Corridor 16-17

Pyramid Lake

Corridor Purpose and Rationale

Figure 3. Map of Conflict Areas in Vicinity of Corridor 16-17

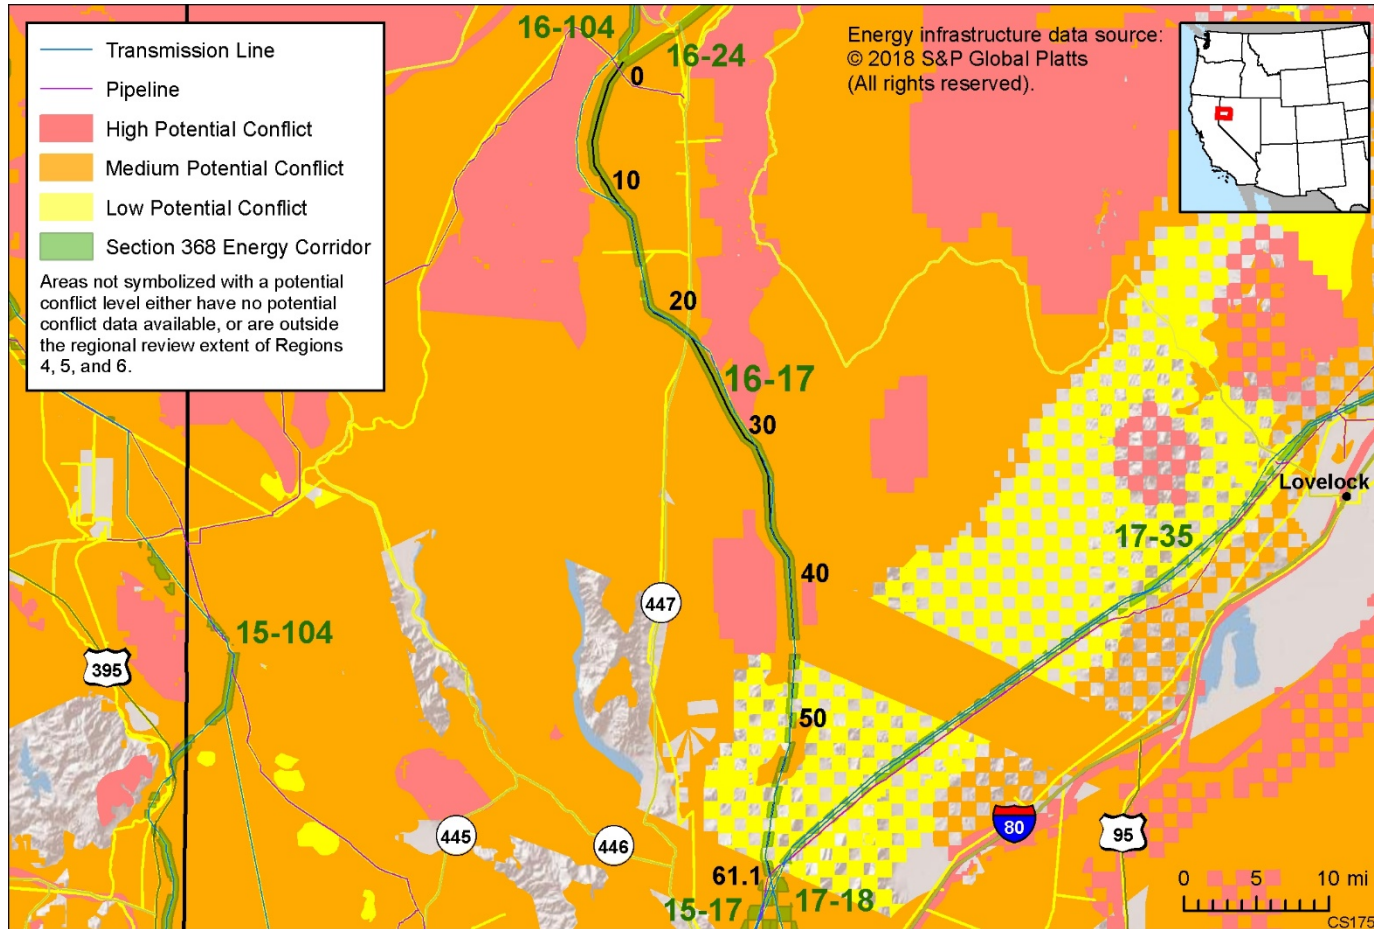
Figure 3 reflects a comprehensive resource conflict assessment developed to enable the Agencies and stakeholders to visualize a corridor’s proximity to environmentally sensitive areas and to evaluate options for routes with lower potential conflict. The potential conflict assessment (low, medium, high) shown in the figure is based on [criteria](#) found on the WVEC Information Center at www.corridoreis.anl.gov. To meet the intent of the Energy Policy Act and the Settlement Agreement siting principles, corridors may be located in areas where there is potentially high resource conflict; however, where feasible, opportunity for corridor revisions should be identified in areas with potentially lower conflict.
